Device **C504-2E**
Marking/Step **Step CC**
Package **P-MQFP-44**

This Errata Sheet describes the deviations from the current user documentation.

Figure 1 Reset Circuitries

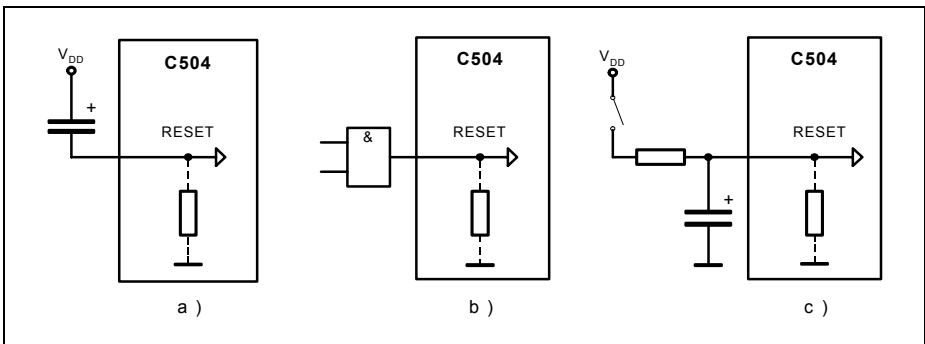
RST.1: Figure in User’s Manual and Data Sheet regarding the Reset Circuitries is incorrect

Figure 5-1 in User’s Manual and Figure 6 in Data Sheet show incorrectly that the RESET pin has an internal pullup resistor connected to the V_{DD} . Instead, at the RESET pin, an internal pulldown resistor is connected to the V_{SS} . The correct implementation is illustrated in [Figure 1](#).

This correction will be updated to the future versions of the User’s Manual and Data Sheet.
